Access Compliance Report

Public Rights-of-Way

(Curb Ramps)

Intersection ID: 10038172	Main Street: SIR_CHARLES_PL	Cross Street: N/A	Location: NE
ADA ID: 0986E6578050	Ramp Type: PerpDiag	Initial Pass/Fail: Fail	Overall Compliance: No
		Severity Score: 42.5

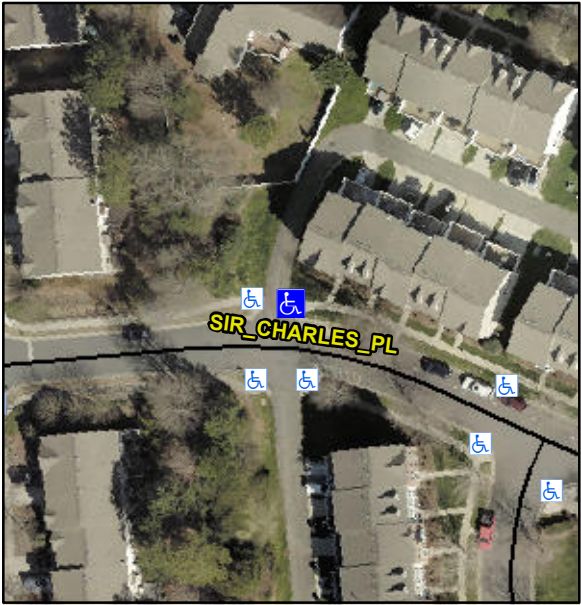
Codes/Mitigation Info/Possible Solution			Field Measurements/Component Compliance		
	Possible Solutions:		Compliance	Description	Data
	Remove & Replace Curb Ramp With Two New Directional Ramps or Equivalent.		N/A	Ramp Length (in)	61.0
			No	Ramp Width (in)	34.0
			N/A	Flare Type LT	N/A
			N/A	Flare Slope LT (%)	N/A
			N/A	Flare Traversable LT?	N/A
			N/A	Landing Length (in)	N/A
			N/A	Landing Width (in)	N/A
			N/A	Landing Slope (%)	N/A
			N/A	Landing X Slope (%)	N/A
<p>Surveyor Notes:</p> <p>N/A</p> <p>PROW/ADA:</p> <p>Not Found, R304.5.1, R304.2.2</p>			N/A	Flare Type RT	N/A
			N/A	Flare Slope RT (%)	N/A
			N/A	Flare Traversable RT?	N/A
			N/A	DWS Provided?	N/A
			N/A	DWS Contrast?	N/A
			N/A	DWS Length (in)	N/A
			N/A	DWS Full Width?	N/A
			N/A	DWS Offset (in)	N/A
			N/A	Shared Landing?	N/A
			N/A	Gutter Ponding?	N/A
			N/A	Gutter Lip Ht (in)	N/A
			N/A	Painted X Walk1?	No
				X Walk 1 Direction	To W
			N/A	X Walk 1 Width (in)	N/A

X Walk 1 Slope (%)	1.3
				X Walk 1 X Slope (%)	2.9
			N/A	Ramp inside XWalk1?	N/A
				Road Slope (%)	0.9
				Road X Slope (%)	0.8
			N/A	Any Obstructions?	N/A
				Obstruction Type	
Total Cost:		\$ 3200.00
